**Additions and Renovations  
Platt Technical High School  
Milford, CT**

**ADDENDUM NO. 9**

August 29, 2019

PRECAST CONNECTION DETAIL.  
ADDENDUM NO. 9

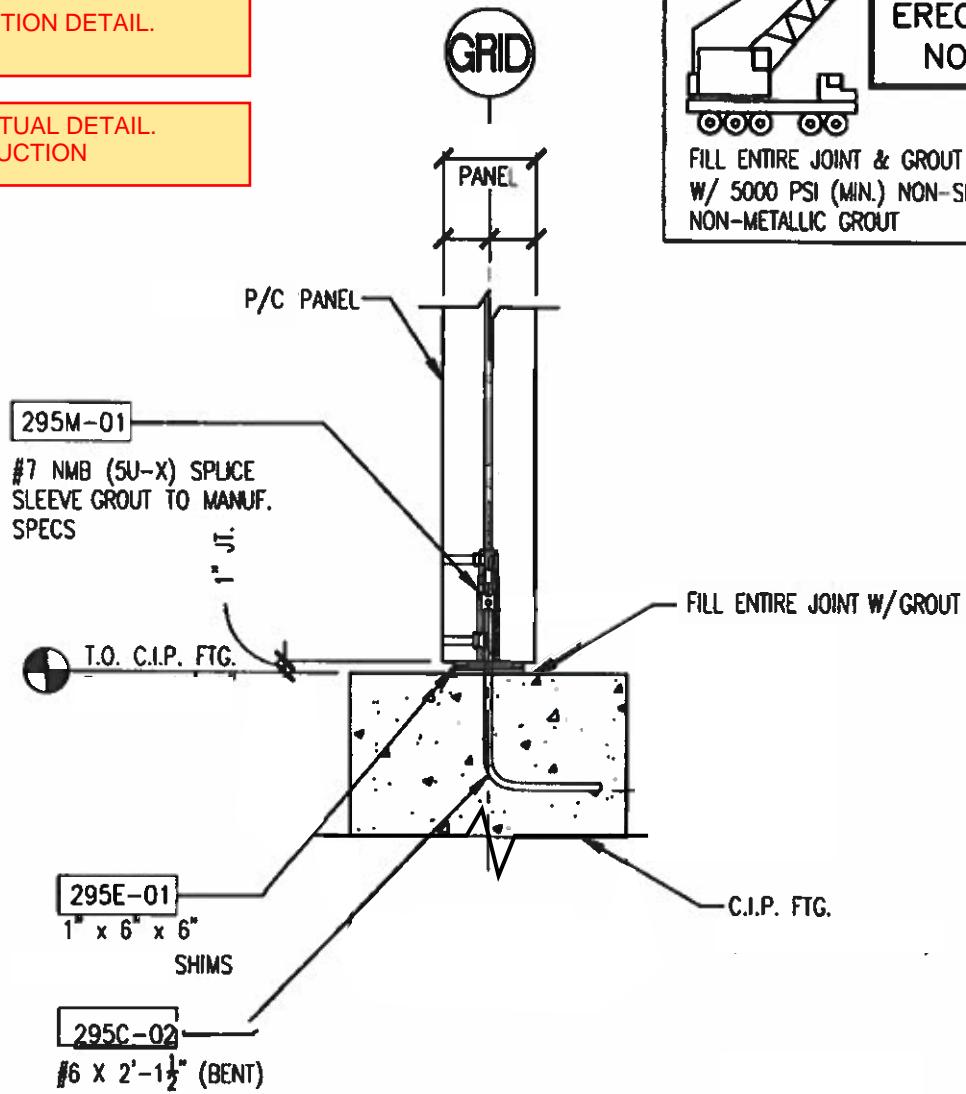
- ADD 9-006**      **SECTION 00 41 10 – BID PACKAGE SUBMITTAL REQUIREMENTS**  
BID PACKAGE No.03, Concrete:  
Per the attached Sketch from the Precast Supplier, Precast Connection Details:  
This is a reference to Detail F1A on Drawing S3-1-1.  
The count of the sleeves in reference to the bottom of the Precast Wall Panels as shown at 48" O.C. is 882 pieces.

FILL ENTIRE JOINT & GROUT TUBE  
W/ 5000 PSI (MIN.) NON-SHRINK,  
NON-METALLIC GROUT

**882 pcs**

### 2 CHAIN LINK FENCE

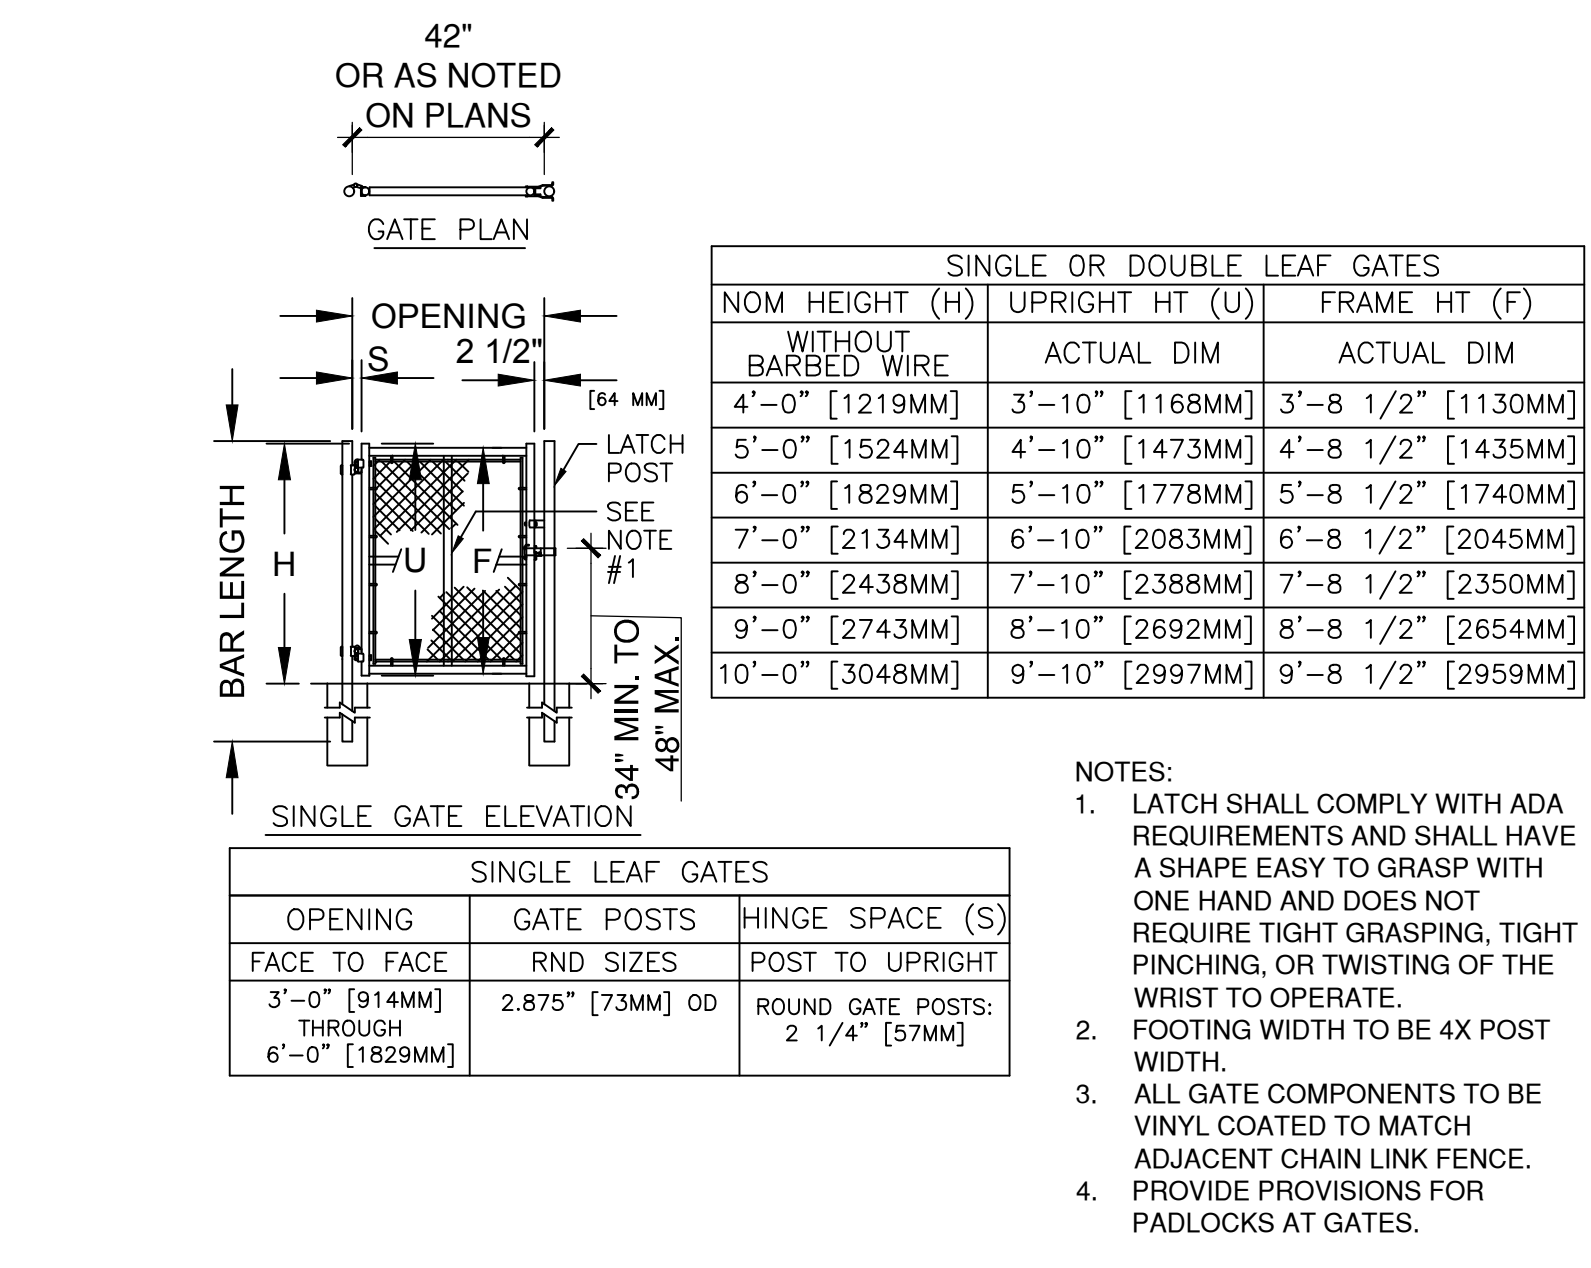
- ADD 9-013      DRAWING L-503– SITE DETAILS**  
Modify Detail 2 Chain Link Fence REVISE dimension for footing as noted. Refer to revision tag RL9-01.
- ADD 9-014      DRAWING L-507– SITE DETAILS**  
Modify Detail 5 Baseball Backstop ADD footing 2'-4" Dia. dimension as noted. ADD "6 5/8" Post, 1.66" Top Mid and Bottom Rails" as noted. Refer to revision tag RL9-02.  
Modify Detail 6 Softball Backstop ADD footing depth 5'-6" Min. and 1'-4" Dia. dimensions as noted. ADD "4" Post, 1.66" Rails, and 2 3/8" Hood Framework" as noted. Refer to revision tag RL9-03.
- ADD 9-015      DRAWING L-508– SITE DETAILS**  
Modify Detail 5 Batting Cage ADD footing depth 4' Min. and 1'-4" Dia. dimensions as noted. ADD "4" Post, 1.66" Rails" as noted. ADD "1 7/8" Strut" as noted. ADD 2 3/8" Roof Framing and Support Structure" as noted. Refer to revision tag RL9-04.
